STAFF REPORT

RZ/FDP 2000-PR-027

REZONING APPLICATION /
RZ 2000-PR-027

MORADA RIDGE

POSSIBLE ELEVATIONS FOR LOTS 1-5
NOT TO SCALE

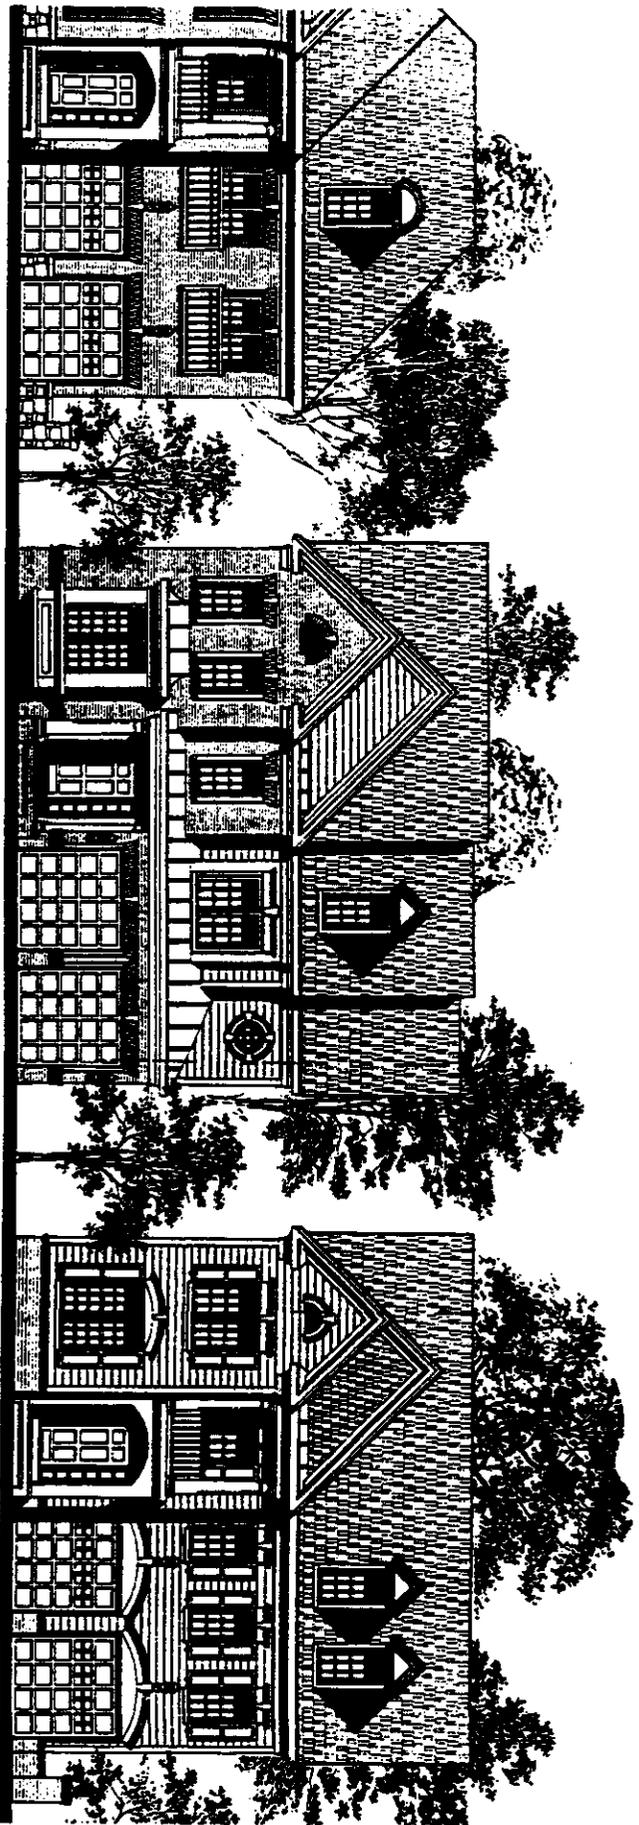
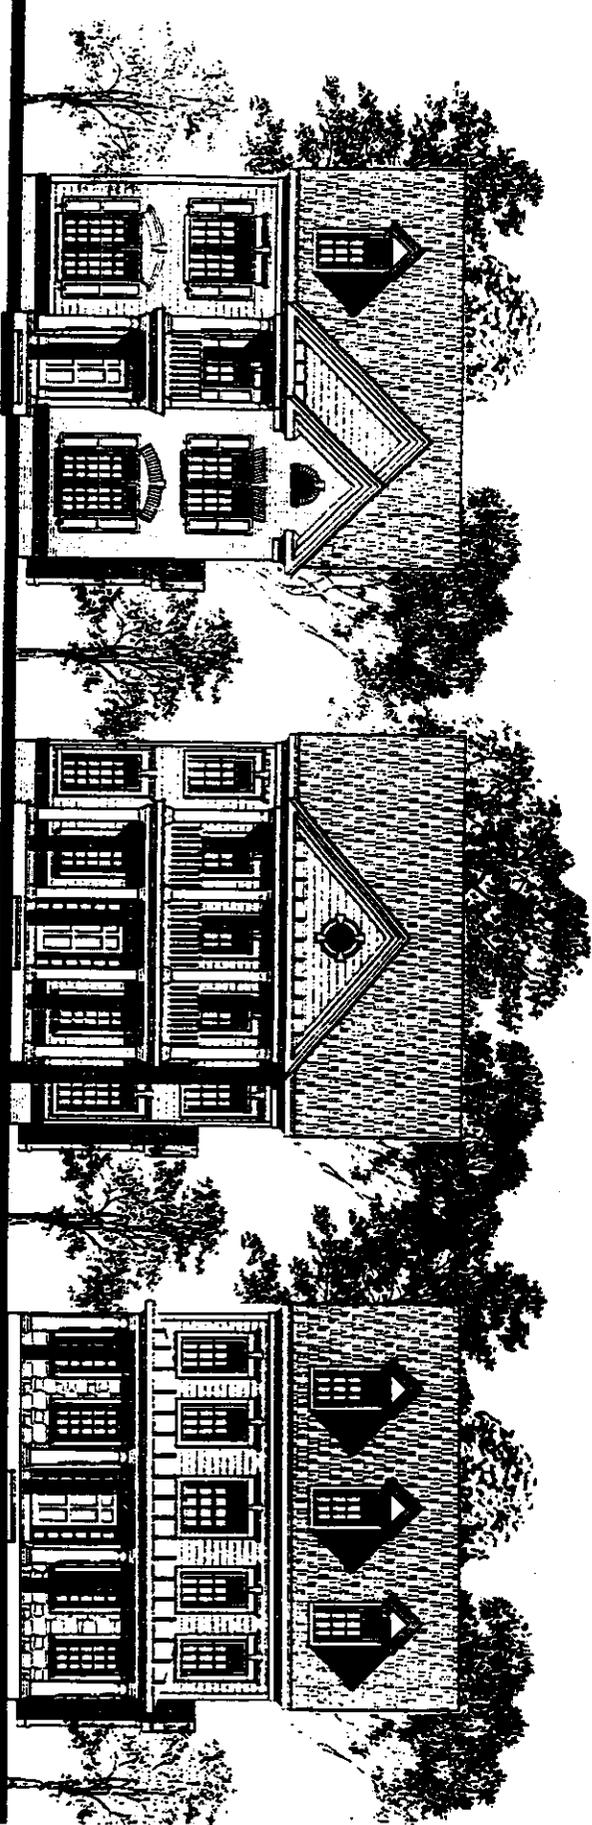
- Lots 1 and 6, 7, and 8 have frontage on Hilltop Road. Sheet 4 shows possible front building elevations which would apply to Lots 6, 7, and 8; however, the dwelling proposed to be built on Lot 1 will have its side façade oriented toward Hilltop Road and no side elevations have been provided. The applicant's draft proffers now state that "... the side of the dwelling on Lot 1 facing Hilltop Road and the east and west sides of the dwellings on Lots 8 and 6, respectively, are designed with an architectural style that is unified with the front façade to include a minimum of a brick or stone water table and the incorporation of four windows.

Sheet 4 contains front building elevations labeled "Possible Elevations". The elevations shown for Lots 1-5 depict two-story dwellings with two-car garages at the front. Those shown for Lots 6-8 are also two-story but, since these lots will be accessed from within the development, the garages do not face the front. Building materials are not labeled but appear to be brick or siding or a combination of the two and a combination of siding and stone.

The proposed development provides for single-family detached dwellings designed to present front facades to Hilltop Road which will enhance the appearance of the project. Front building elevations have been provided on Sheet 4 of the CDP/FDP. Staff has proposed a development condition which addresses building materials for the side of the dwelling on Lot 1 and the western and eastern sides of Lots 6 and 8, respectively. Appropriate buffers are provided toward the west which is developed with a single-family dwelling in the R-1 District. Appropriate buffers are provided between this development and the adjacent townhouse community; although, staff has proposed a development condition which requires supplementation of this area with additional plantings to address deficiencies. Front yards of twenty-five (25) feet are provided for the dwellings on proposed Lots 6, 7, and 8. Lot 1, shows only a fifteen (15) foot front yard; however, the yard measures twenty (20) feet on the CDP/FDP. Staff has proposed a development condition to require a twenty (20) foot front yard which is consistent with that required in the R-4 cluster provisions. Given the fact that the property across Hilltop Road is planned for a density of 1-2 du/acre, it would be desirable for more landscaping to be provided along this frontage. The applicant declined to show additional landscaping on the CDP/FDP; therefore, staff has proposed a development condition which requires additional plantings along Hilltop Road, subject to Urban Forestry approval.

20. At the time of subdivision plan approval, the Applicant shall demonstrate to the satisfaction of DPWES that the side of the dwelling on Lot 1 facing Hilltop Road and the east and west sides of the dwellings on Lots 8 and 6, respectively, are designed with an architectural style that is unified with the front façade to include a minimum of a brick or stone water table and the incorporation of a minimum of four windows. Windows on the sides of the dwellings governed by this proffer shall incorporate shutters or similar decorative treatments.
